US-APWR Design Control Document

Note : This is excerpt from Tier 2 Ch.9 Change List as of 7/29/2011 and will be finalized in the 1st Tracking Report of DCD Rev.3.

Chapter 9 Change List

Figure 19.1-2 Simplified System Diagram (Sheet 28 of 42) (Alternate Containment Cooling by Containment Fan Cooler System - Normal Operation)

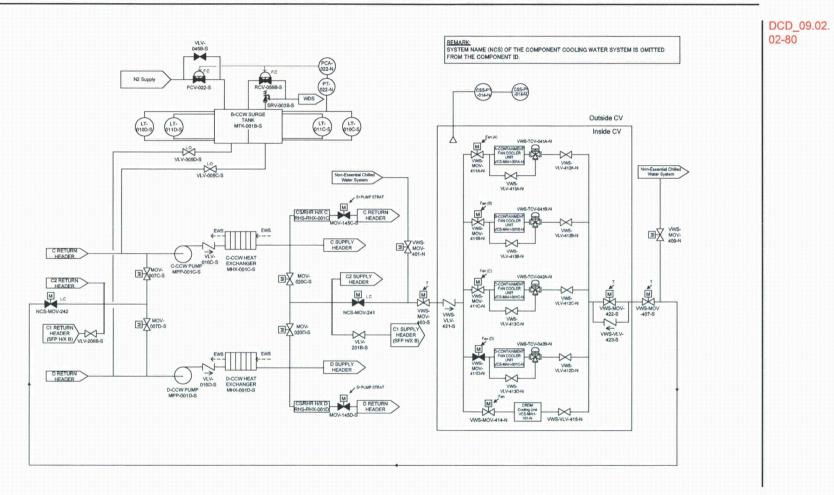
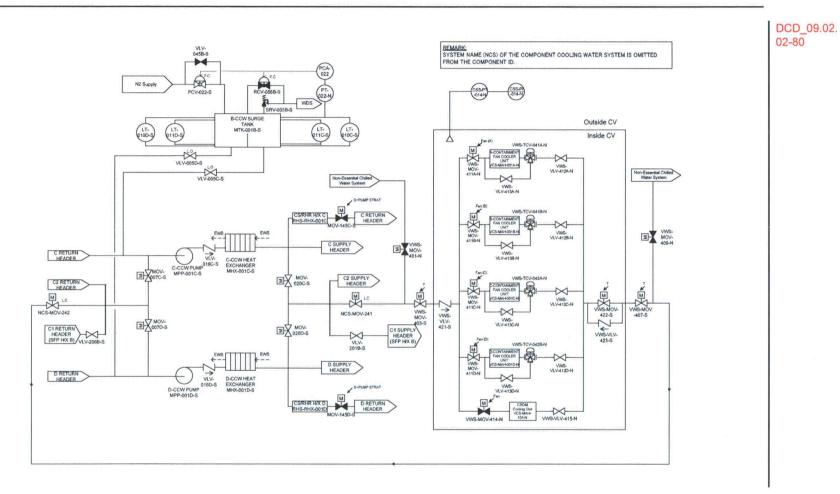
Change ID No.	Location (e.g., subsection, table, or figure)	DCD Rev.3 Page *	Reason for Change	Change Summary	Rev. of T/R
DCD_06.04-14	9.2.7.2.1 9.2.7.2.2	9.2-45 9.2-46 9.2-48	Response to RAI No. 691 MHI Letter No. UAP-HF-11061 Date 03/09/2011	Revised the 6th paragraph of Subsection 9.2.7.2.1 for RAI response. Revised the 2nd paragraph of Subsection 9.2.7.2.2 for RAI response.	
RCOL2_12.03- 12.04-11 S02	9.2.6.2.4 Figure 9.2.6-1	9.2-40 9.2-109	MHI Letter No. UAP-HF-11091 Date 04/6/2011	AAdded description about CST overflow in the last of the first paragraph of Subsection 9.2.6.2.4. Added CST overflow line in Figure 9.2.6-1	-
DCD_09.02.02- 80	9.2.2.2 9.2.7.2.1 9.3.4.2.6.1	9.2-18 9.2-46 9.3-30	Response to RAI No. 697 MHI Letter No. UAP-HF-11133	Added description about alternative cooling of the charging pumps and the containment fan	-

Change ID No.	Location (e.g., subsection, table, or figure)	DCD Rev.3 Page *	Reason for Change	Change Summary	Rev. of T/R
	9.4.7			units stop for one hour after a SBO occurs until alternate ac gas turbine generator restores power (Chapter 8, Section 8.4)."	
				Added the ninth paragraph.	
				Revised the tenth paragraph as follows;	
				"WaterThe ECWS is a closed-loop system and water chemistry control of ECWS is performed by adding chemicals to the chemical feed tanks to prevent long-term corrosion that may degrade system performance." Added the description about system operation of	
				essential chilled water system.	
				Added the description about alternate cooling in severe accident.

Figure 2.7.3.3-1 Component Cooling Water System (Sheet 2 of 2)

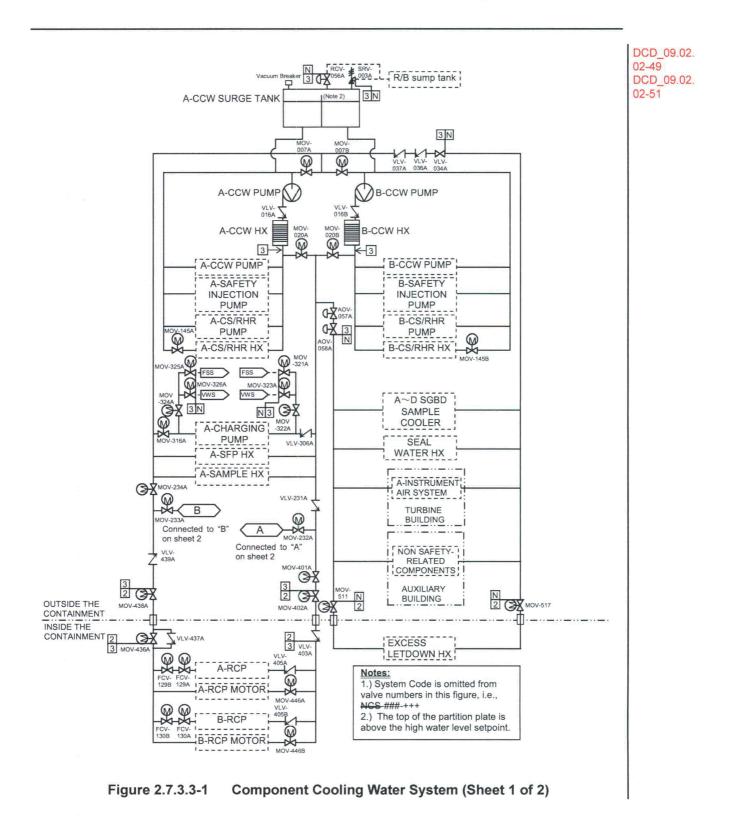
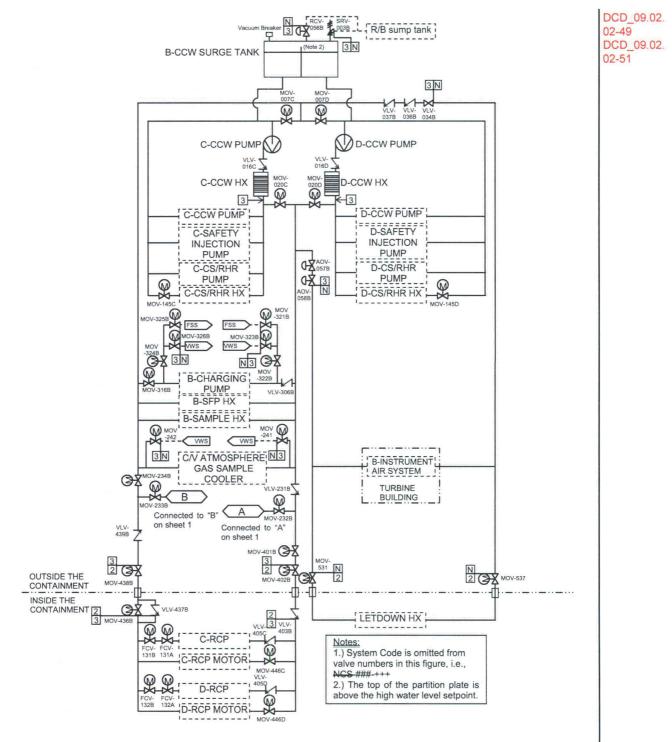
- 1.a The functional arrangement of the CCWS is as described in the Design Description of Subsection 2.7.3.3 and in Table 2.7.3.3-1 and as shown in Figure 2.7.3.3-1.

- 1.b Each mechanical division of the CCWS (Divisions A, B, C & D) with the exception of that portion of the system consisting of the supply headers A2 & C2as shown in Figure 2.7.3.3-1, is physically separated from the other divisions so as not to preclude accomplishment of the safety function.
